4 February 2021

Selwyn District Council
Attention: Jocelyn Lewes

**PRIVATE PLAN CHANGE REQUEST TO THE OPERATIVE
SELWYN DISTRICT PLAN- RFI
PC200073: DUNNS CROSSING ROAD, ROLLESTON**

OUTLINE DEVELOPMENT PLAN 40 - SKELLERUP BLO

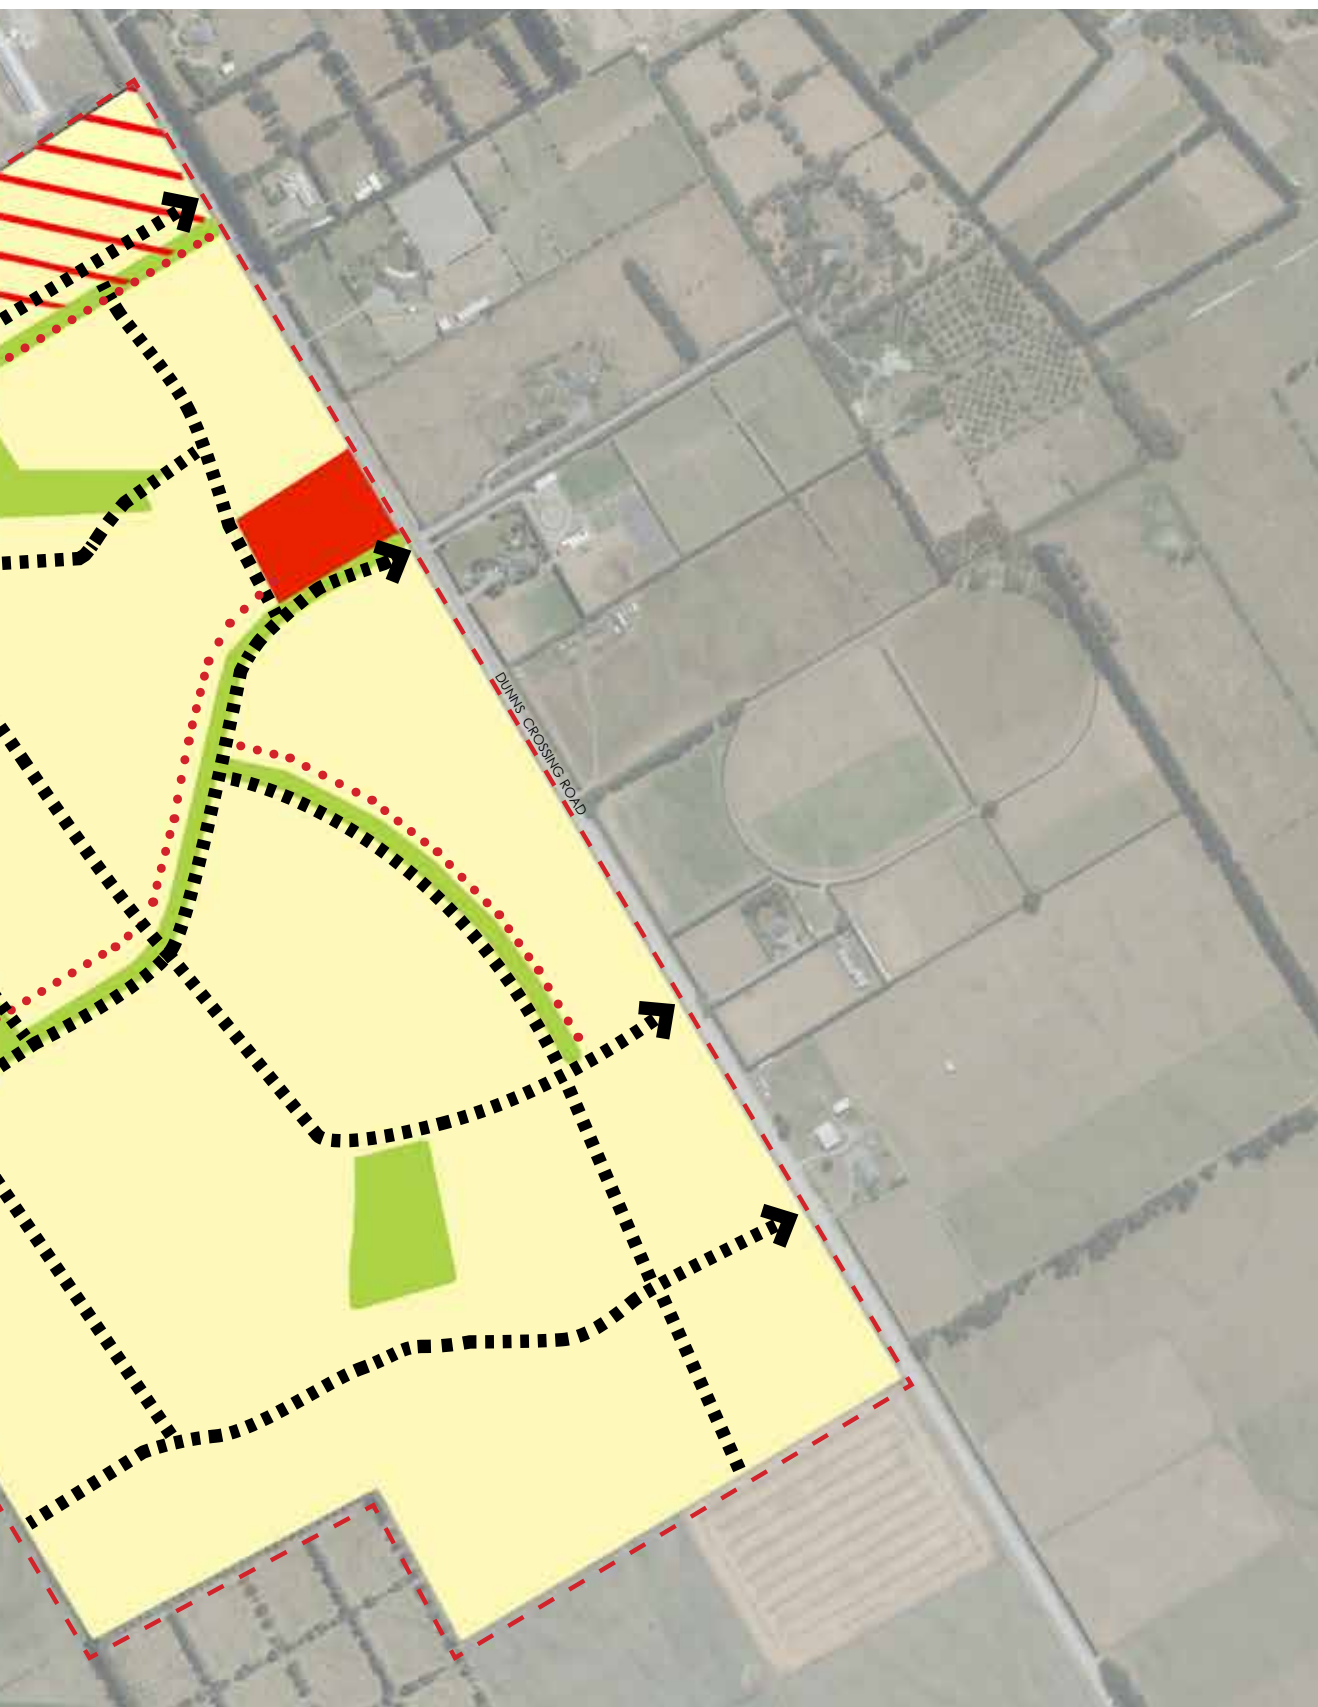
16. *In terms of the Skellerup block, please provide clarification of the rationale for the number and location of the reserves. The spatial distribution maps in the Landscape and Urban Design Assessment with a 500m radius indicate that two reserves would be sufficient from a distribution perspective (the centre one is not strictly required but it is noted this is adjacent to medium density). As such, a pocket park in this location may be more appropriate.*

35. The middle reserve has been changed to a Pocket Park to serve the adjacent medium density lots.
36. This amendment is shown in the revised ODP included in **Attachment 3**.

Attachment 3: ODP Alignment

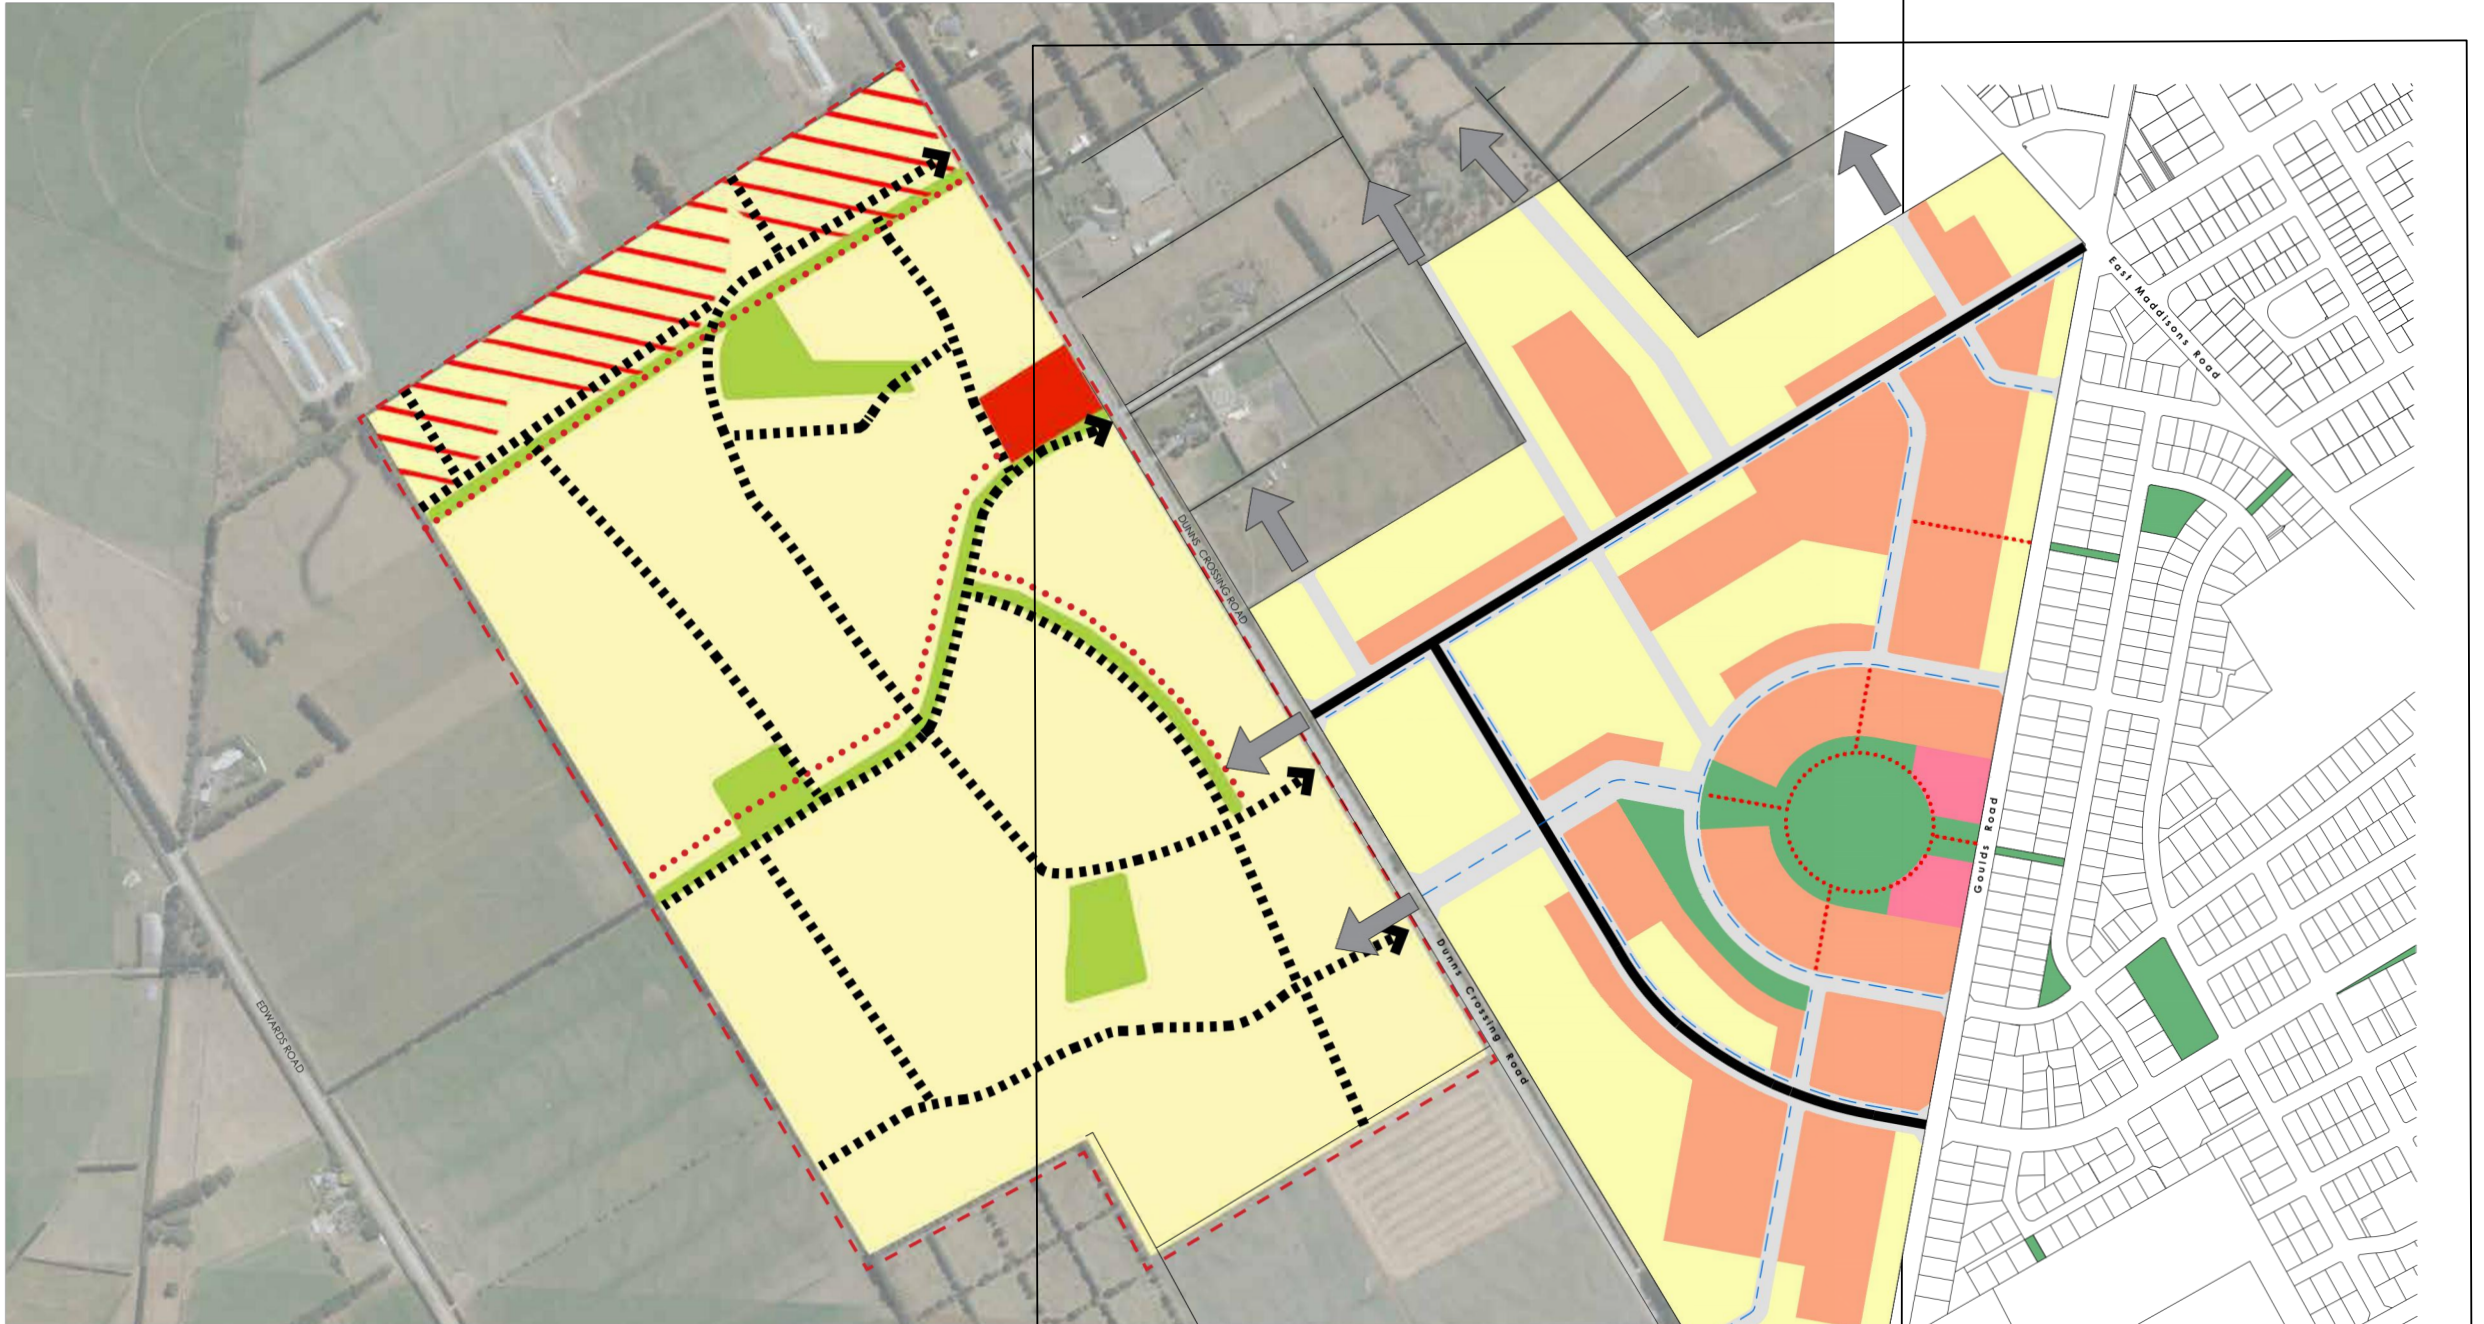
27. In regards to the Skellerup Block the ITA needs to look more carefully at the possible alignment (or otherwise) of the roading and transport connections with the proposed PC70 area opposite and assess intersection type and alignments and LoS to provide confidence on this aspect. This should be coordinated with the PC70 Applicant.

50. The plan attached to Novo Group's traffic response in **Attachment 4** illustrates the alignment of the transport networks for this Plan Change 73 and proposed Plan Change 70. The road alignments are considered to be sufficiently well aligned to enable continuous links to be provided.
51. The traffic response otherwise predicts that these intersections (including the Primary Access intersection) will operate at Level of Service A, with low levels of delay.
